9.5 Other Auxiliary Systems

The information in this section of the reference ABWR DCD, including all subsections, tables, and figures, as modified by the STP Nuclear Operating Company Application to Amend the Design Certification rule for the U.S. Advanced Boiling Water Reactor (ABWR), "ABWR STP Aircraft Impact Assessment (AIA) Amendment Revision 3," dated September 23, 2010 is incorporated by reference with the following departures and supplements.

STD DEP T1 3.4-1	STD DEP 9.5-2 (Figure 9.5-3, replaced entire figure)
STP DEP 1.1-2 (Figures 9.5-2, 9.5-4 and 9.5-5)	STD DEP 9.5-3
STP DEP 1.2-2 (Table 9.5-5)	STD DEP 9.5-4
STD DEP 8.3-1	STP DEP 9.5-6 (Figure 9.5-6)
STD DEP 9.4-2 (Table 9.5-5)	STP DEP 9.5-7 (Table 9.5-5)
STD DEP 9.5-1	STD DEP Admin

Figure 9.5-2 Outline - Telephonic Communication System for Single Unit of STP 3 or 4

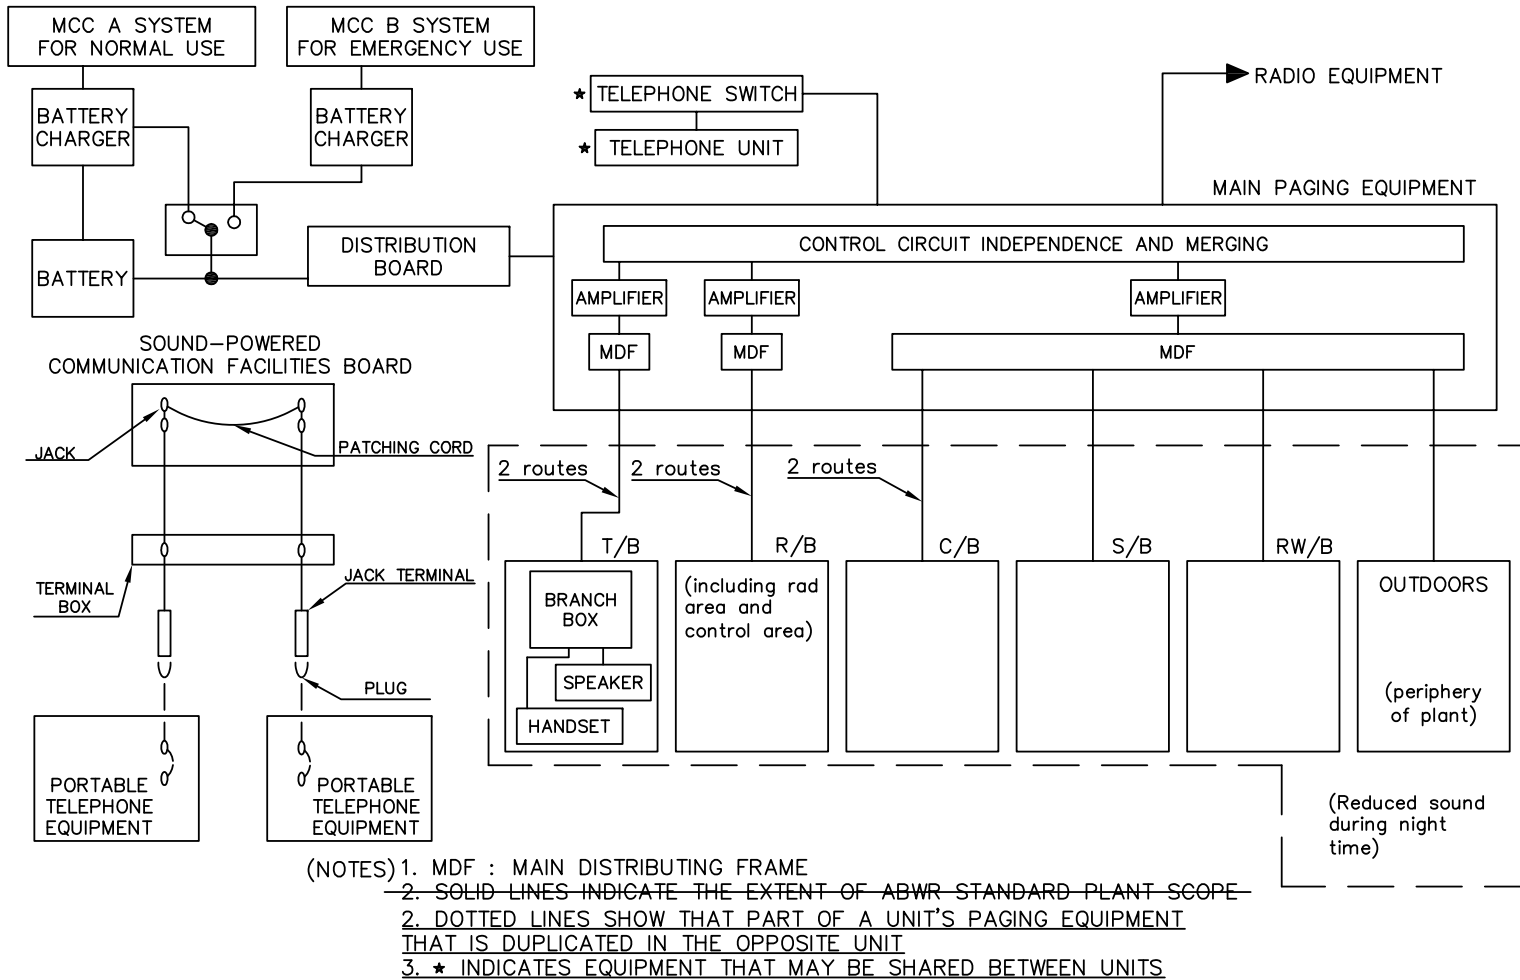
At STP 3 & 4, a common communication system is used to provide plant-wide communications between the dual units. The communication system is not safety-related. A common communication system providing plant wide communications is a safety enhancement since it allows for ease of communication between units. The representative outline of the common communication system is shown in Figure 9.5-2 for STP 3 & 4.

Figure 9.5-4 Fire Protection Water Supply System

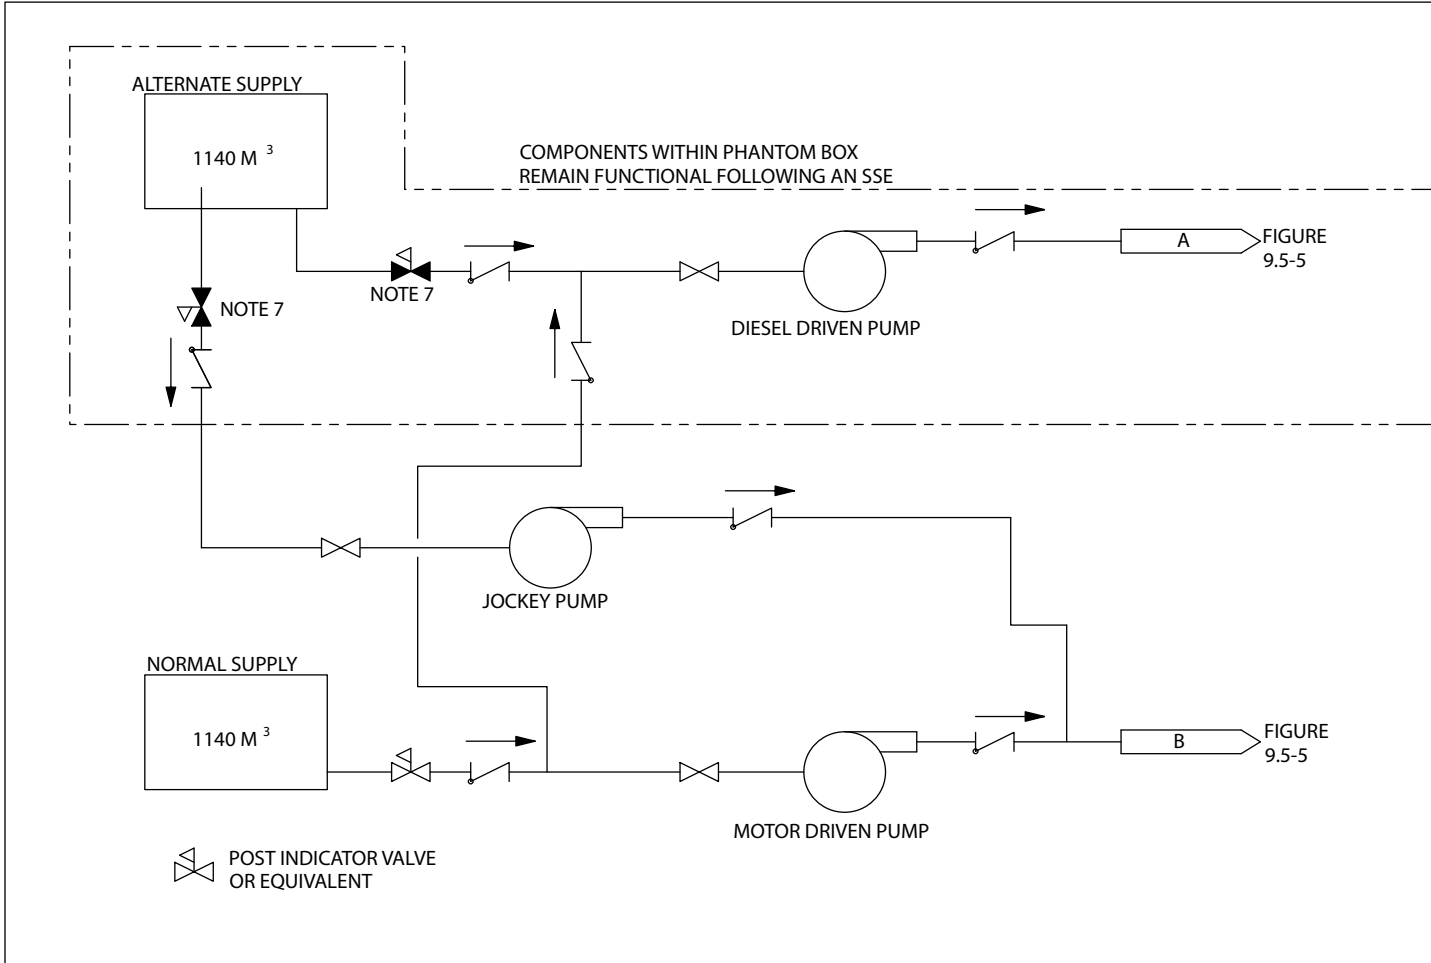
STP 3 & 4 is a dual-unit station. The water supply for fire protection will be shared by STP 3 & 4. A single fire protection pump house and two storage tanks are located within the protected area boundary that provides water for fire suppression to both units via piping in the yard. This common system has the same capability as the system for the single unit design. The fire protection water supply complies with Regulatory Guide 1.189, Rev. 1, which states that a common water supply may be utilized for multi-unit nuclear power plant sites with a common yard fire main loop. The common fire water supply and yard main piping system for STP Units 3 & 4 are depicted in Figures 9.5-4 and 9.5-5. The common yard fire main loop surrounding STP Units 3 & 4 is cross-connected between units in accordance with Regulatory Guide 1.189, Rev. 1.

Figure 9.5-5 Fire Protection Yard Main Piping

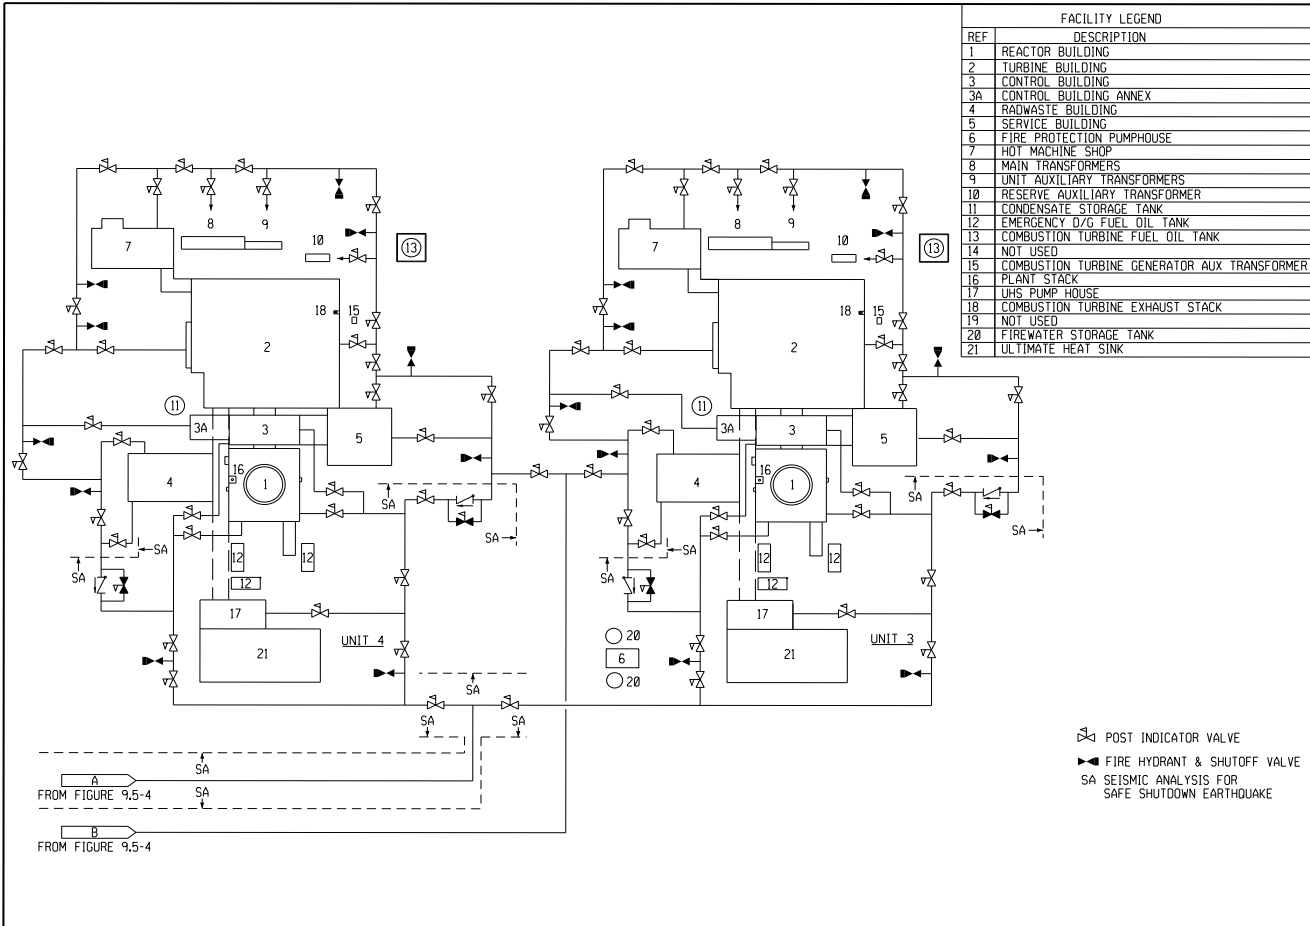
<i>Area</i>	<i>Figures</i>
<i>Reactor Building</i>	<i>9A.4-1 thru 9A.4-10</i>
<i>Control Building</i>	<i>9A.4-11 thru 9A.4-16</i>
<i>Turbine Building</i>	<i>9A.4-17 thru 9A.4-21, <u>9A.4-33 and 9A.4-34</u></i>
<i>Service Building</i>	<i>9A.4-22 thru 9A.4-27</i>
<i>Radwaste Building</i>	<i>9A.4-28 thru 9A.4-32</i>
<i>Plant Yard</i>	<i>9.5-5</i>
